MODEL PARK
BELTERRA ENTRANCE
BECKER ROAD

PSLUSD#5336A
MODEL HOME PARK P19-182

REV	DATE	DESCRIPTION	BY
1	4.6.21	REV DRIVEWAY WIDTHS/SAFE SIGHT

MODEL LOT 143 & PARKING
LANDSCAPE PLAN
BELTERRA
Port St. Lucie, Florida

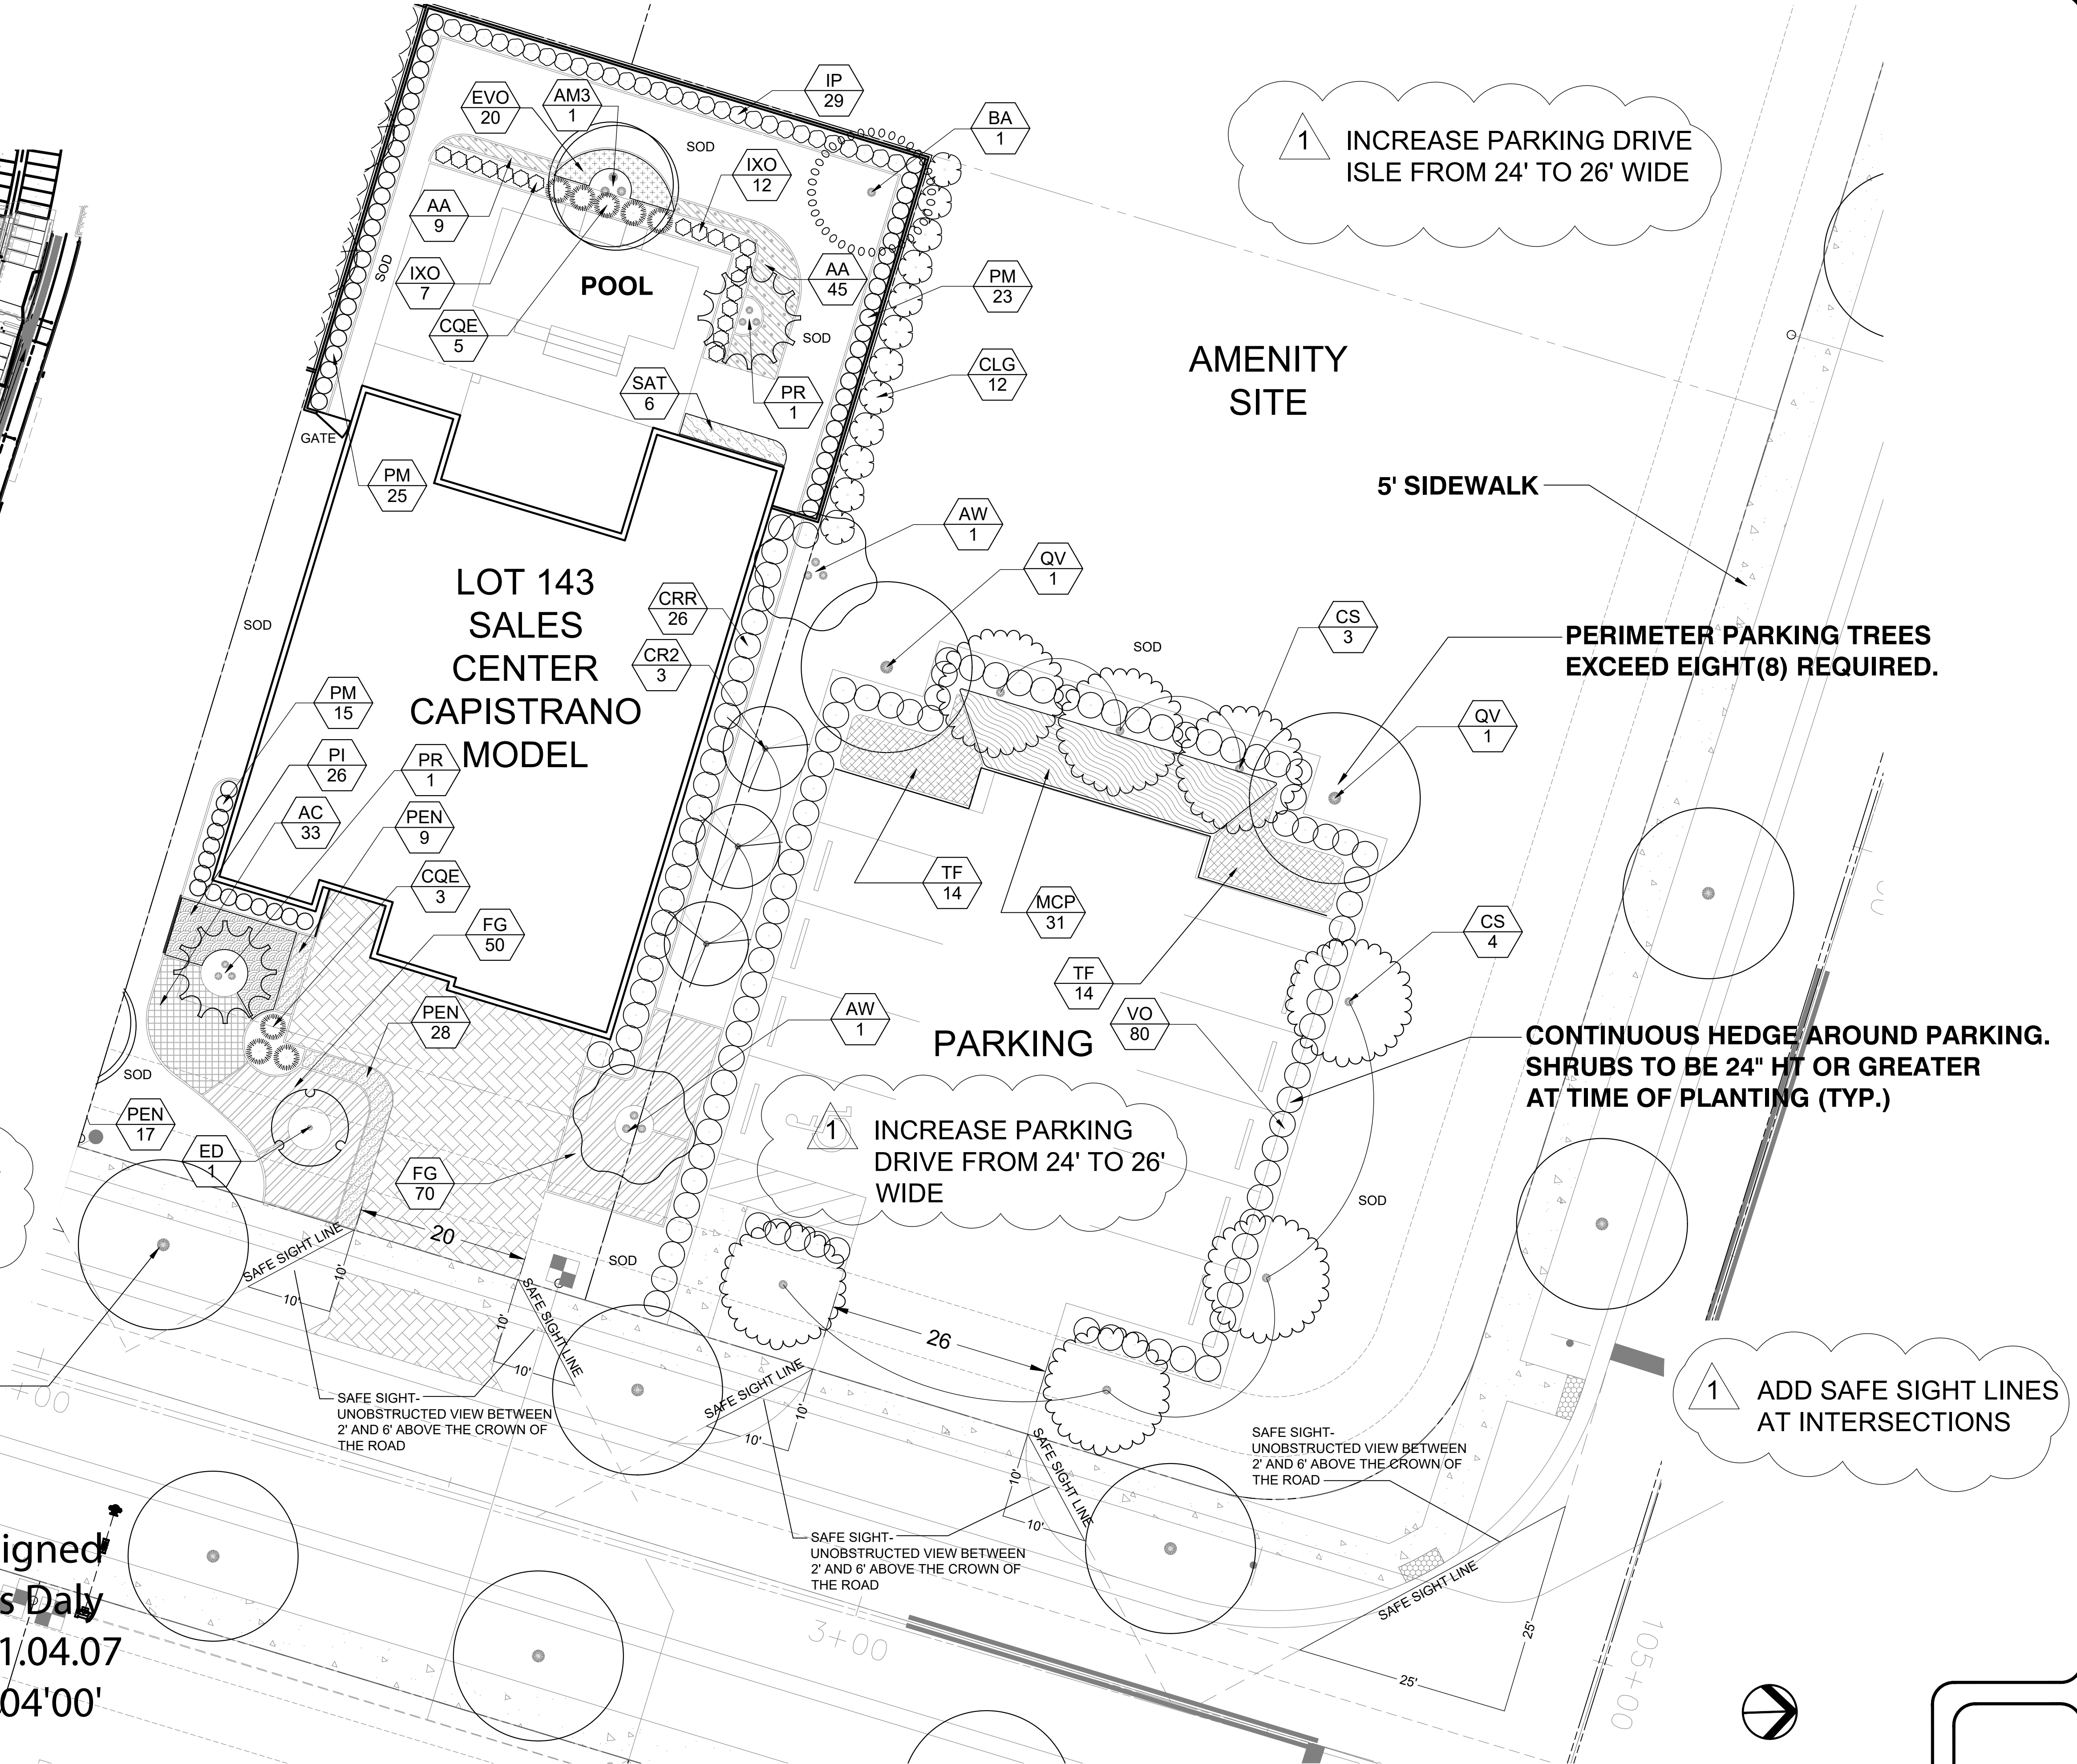
1 INCREASE PARKING DRIVE ISLE FROM 24' TO 26' WIDE

1 INCREASE DRIVEWAY WIDTHS TO 20'

1 INCREASE PARKING DRIVE FROM 24' TO 26' WIDE

1 ADD SAFE SIGHT LINES AT INTERSECTIONS

MODEL LOTS 138/139/140
LANDSCAPE PLAN
BELTERRA
Port St. Lucie, Florida

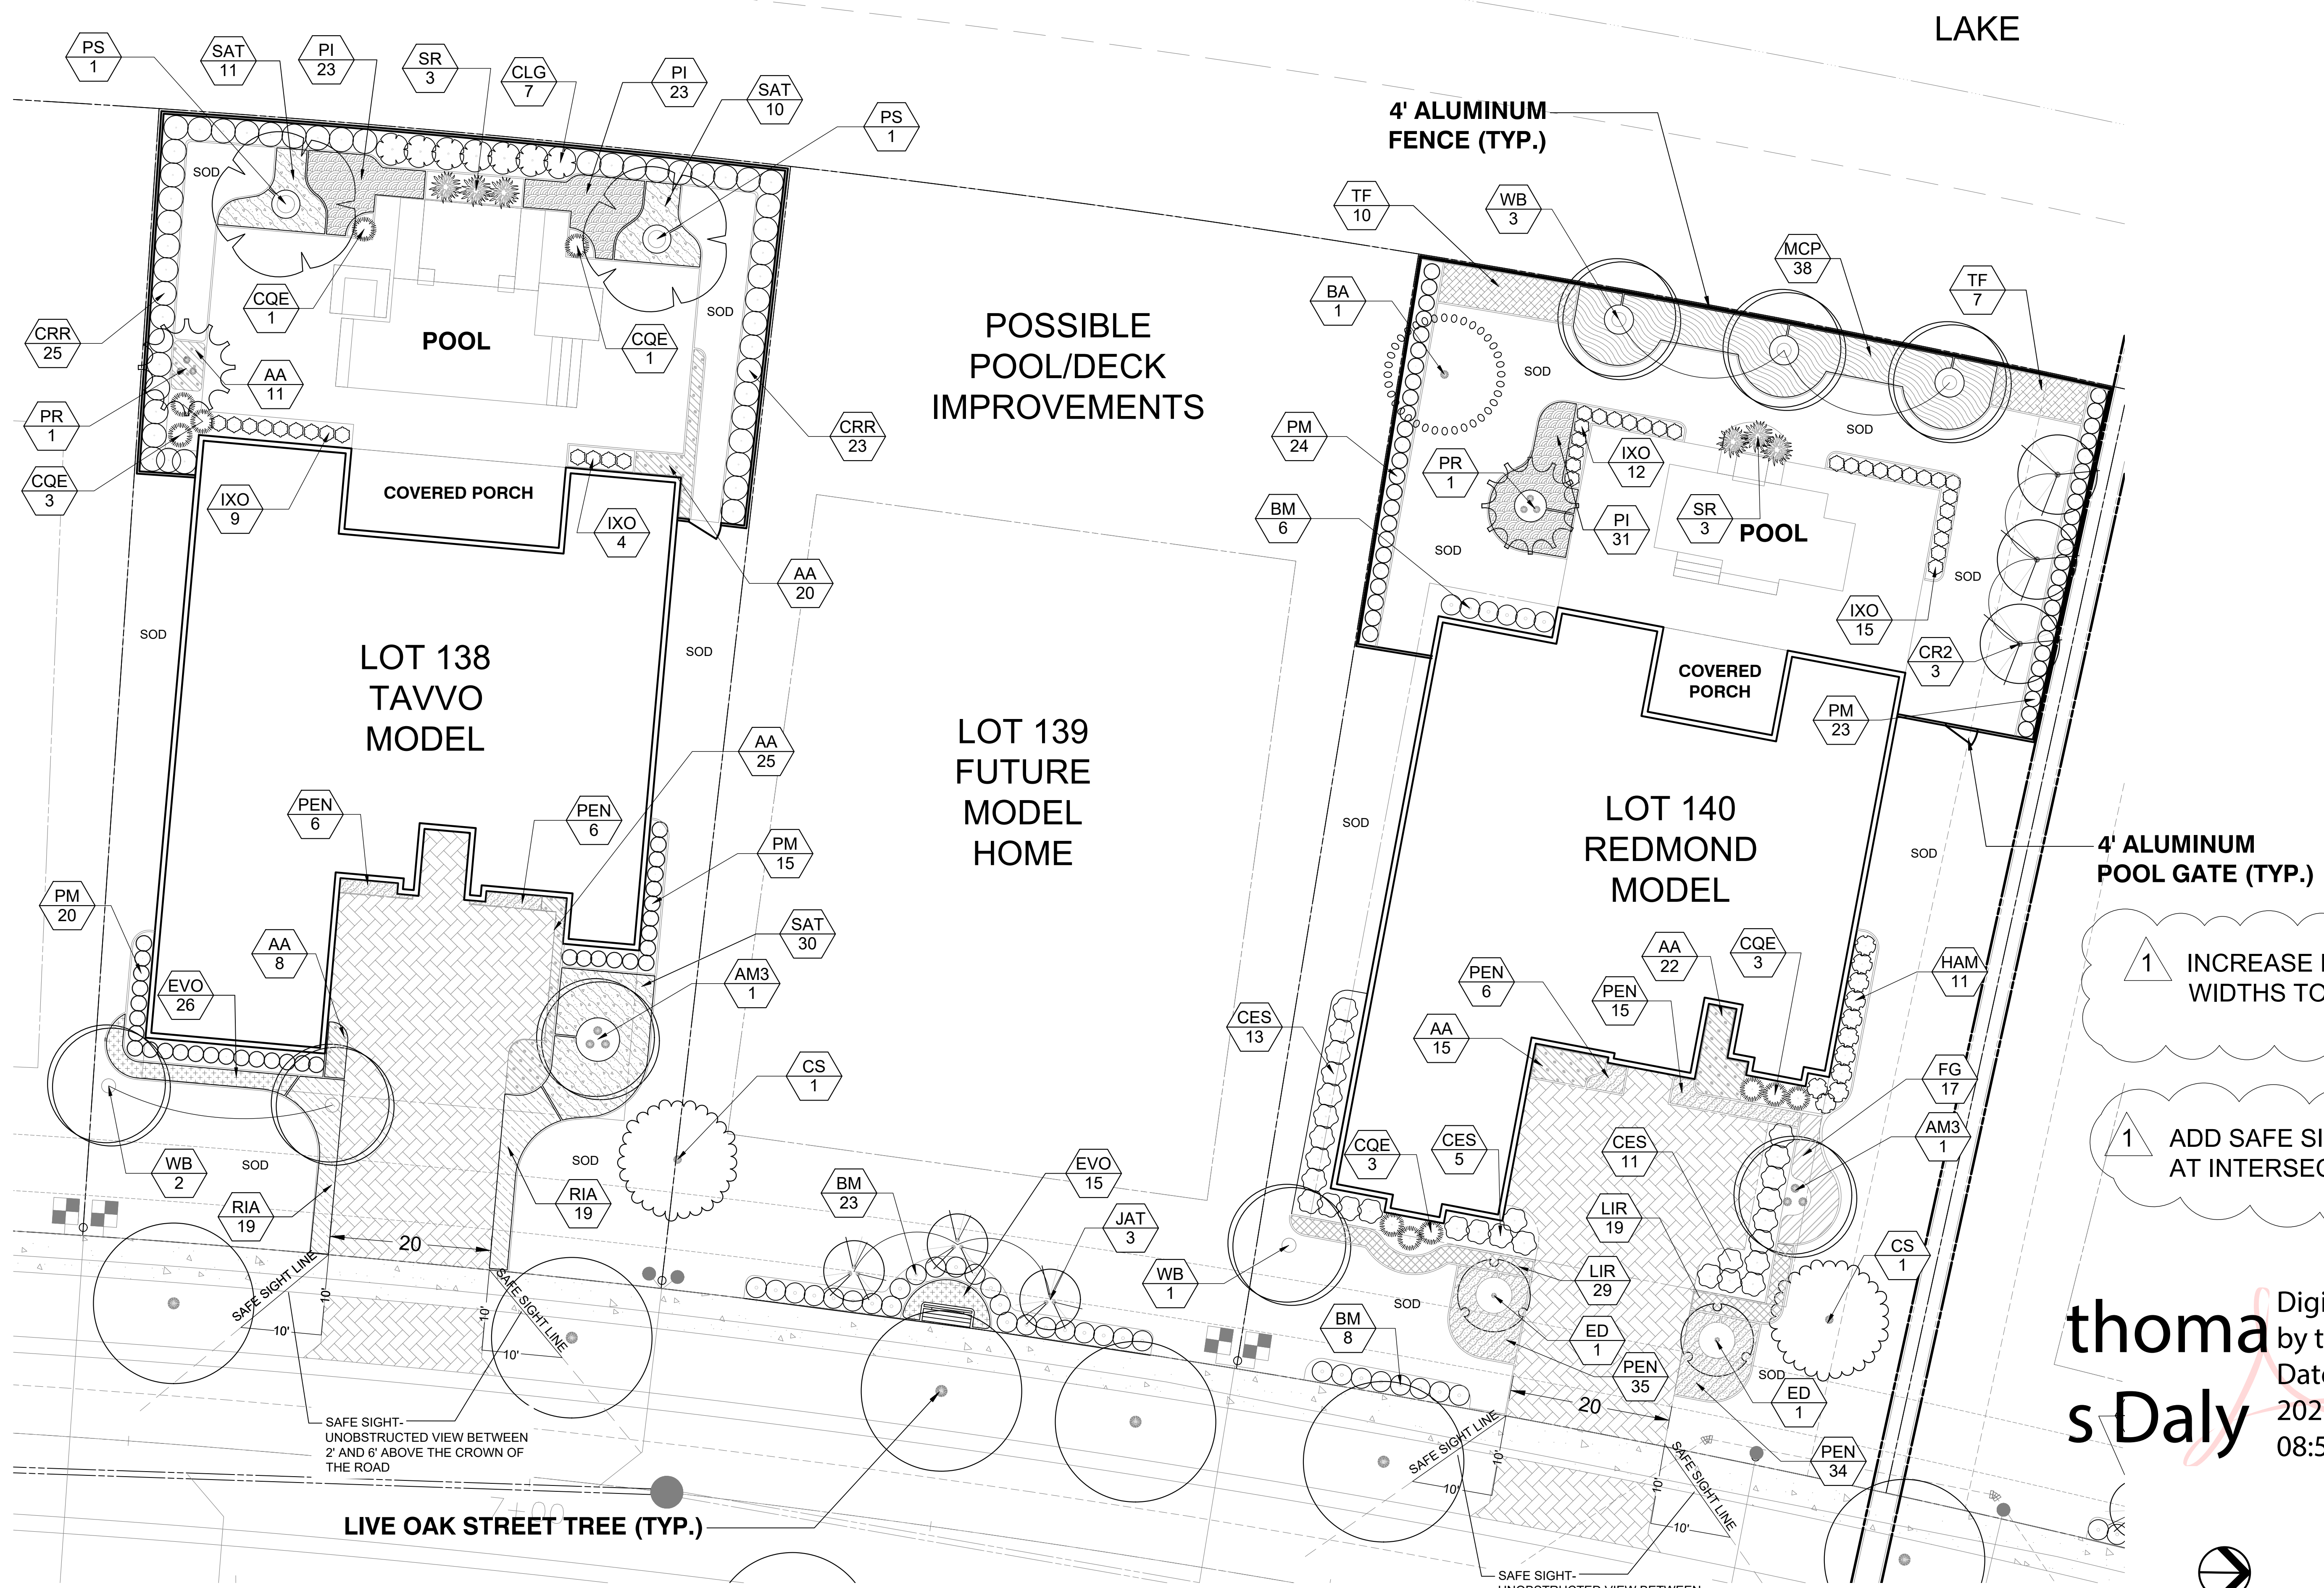
1 INCREASE DRIVEWAY
WIDTHS TO 20'

1 ADD SAFE SIGHT LINES
AT INTERSECTIONS

SAFE SIGHT-
UNOBSTRUCTED VIEW BETWEEN
2' AND 6' ABOVE THE CROWN OF
THE ROAD

SAFE SIGHT-
UNOBSTRUCTED VIEW BETWEEN
2' AND 6' ABOVE THE CROWN OF
THE ROAD

MODEL LOT 141/142
 LANDSCAPE PLAN
 BELTERRA
 Port St. Lucie, Florida

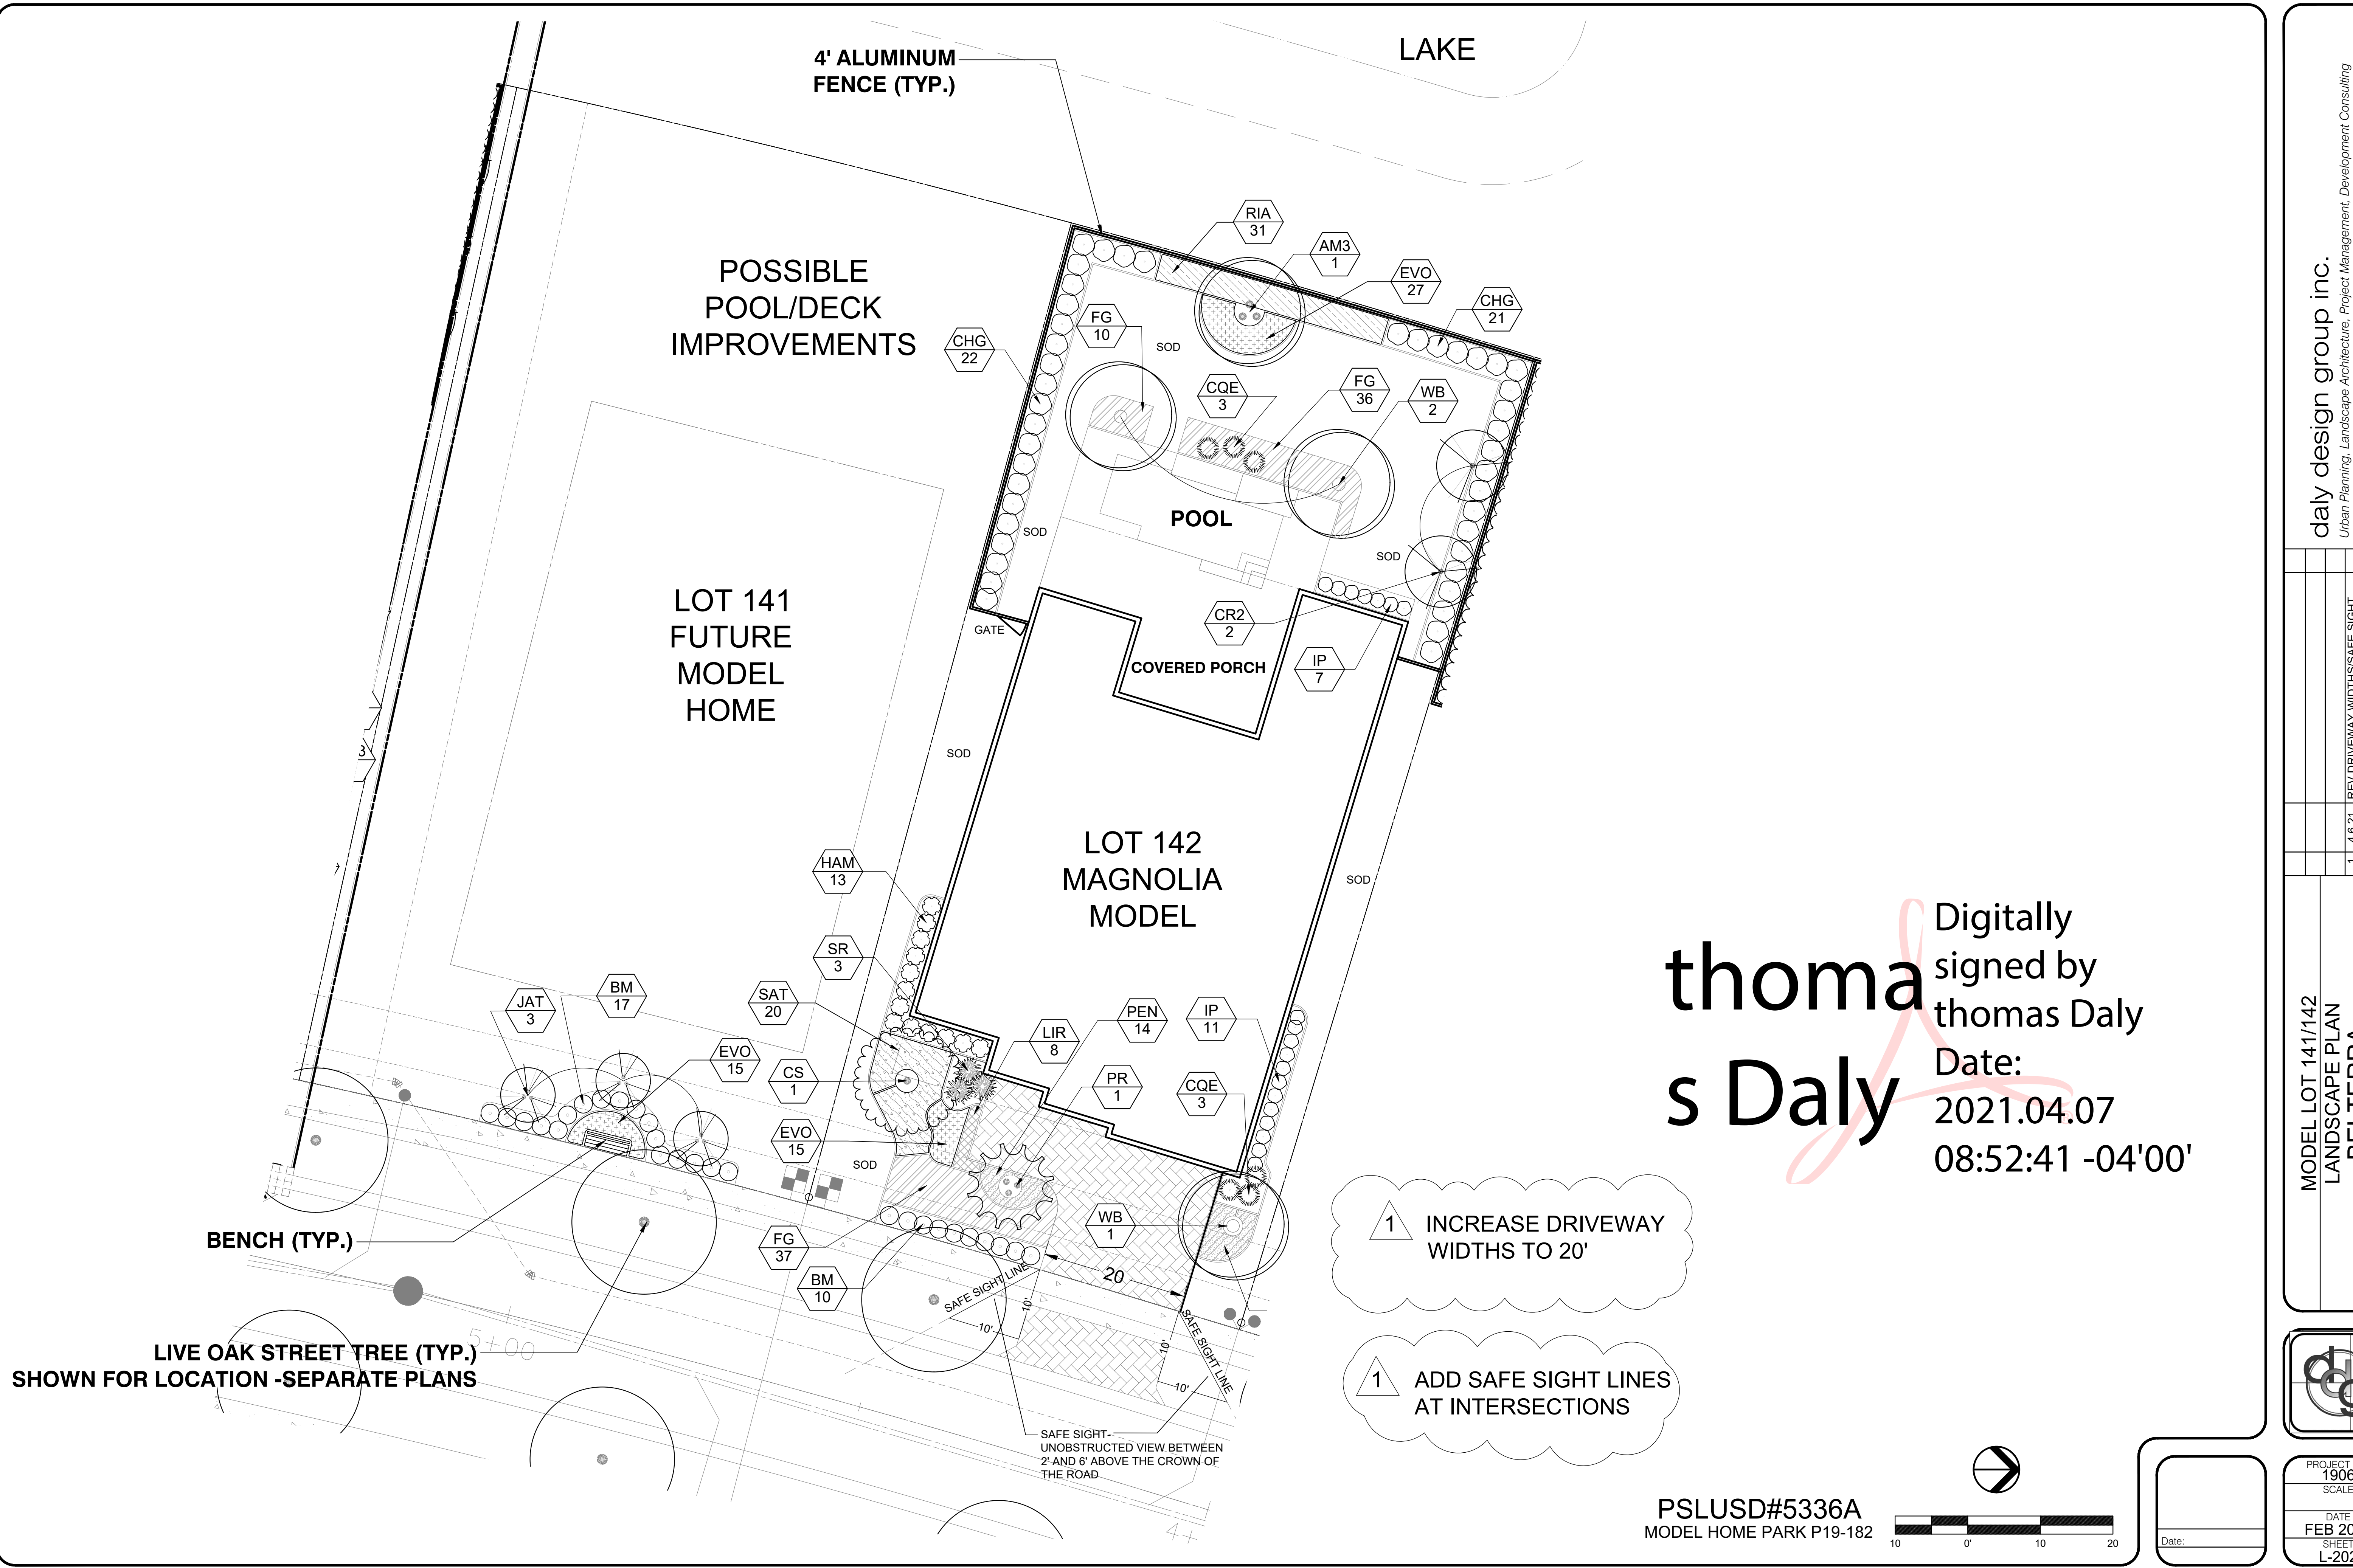
REV	DATE	DESCRIPTION	BY
1	4.6.21	REV DRIVEWAY WIDTHS/SAFE SIGHT
